# KMC CONTROLS

## *FlexStat Backplate Incompatibility*

*Released August 2013*

**(Discontinued) BAC-10000 Series Backplate**

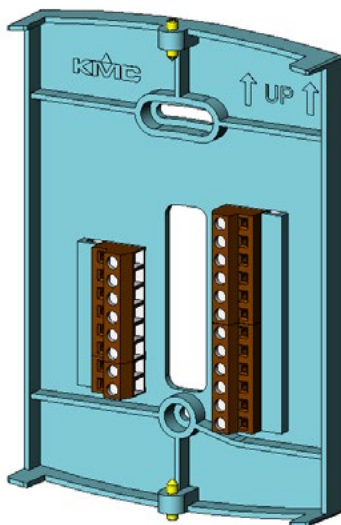
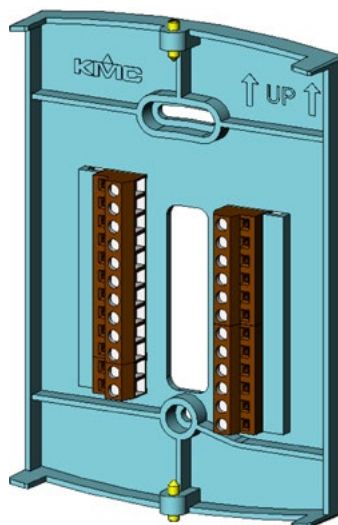
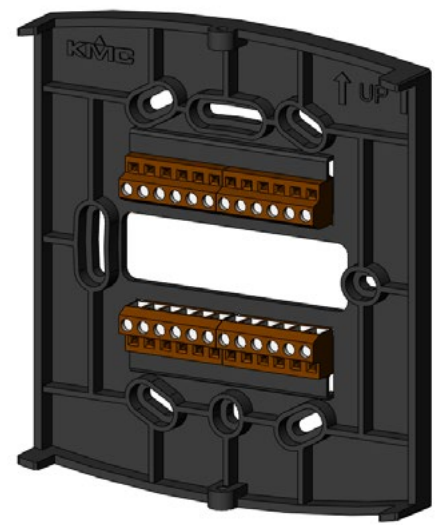
The original BAC-10000 series FlexStats (discontinued in August 2013) had three external inputs. Newer **BAC-12xxxx/13xxxx/14xxxx FlexStats have six external inputs and are not compatible with the older BAC-10000 series backplates.**

BAC-12xxxx FlexStats (with extra pins) can be (improperly) plugged into a BAC-10000 series backplate, resulting in the power, inputs, and MS/TP communications connections being mismatched. **In such a case, that FlexStat will be damaged and possibly the MS/TP communications circuitry of other FlexStats on the same MS/TP network! Even after replacing the backplate and installing a new FlexStat, other FlexStats on the network might no longer communicate properly on the network!**

BAC-13xxxx/14xxxx $CO_2$ FlexStats have a larger backplate with horizontal instead of vertical terminals. These FlexStats are unlikely to be accidentally forced onto a wrong backplate.

When replacing a BAC-10000 series FlexStat with a BAC-12xxxx/13xxxx/14xxxx FlexStat, **replace the old backplate** with the one included with the new FlexStat.
